**M9505A-05-S**

# **S E R V I C E N O T E**

## M9505A AXIe 5 Slot Chassis

**Chassis carry handle may come off while handling**

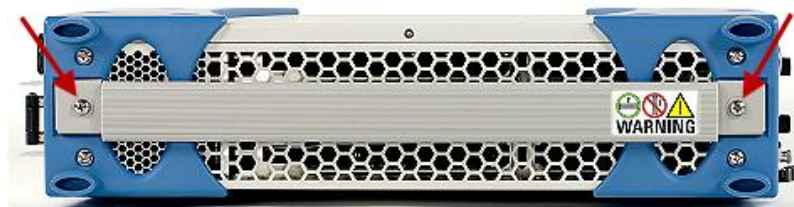
**Situation:**

Chassis carry handle screws may become loose over time causing the carry handle to come off while handling.

Carry handle screws with locking mechanism will prevent this issue. Picture below shows the screw with locking mechanism included in the M9502A and M9505A Handle Screw Kit (M9502-80001).

Replace the screws on the chassis carry handle shown in the picture below. Use 8.7 to 10 in-lbs torque to tighten the screws.

Perform the same step to replace the screws on the second carry handle on the other side of the chassis.
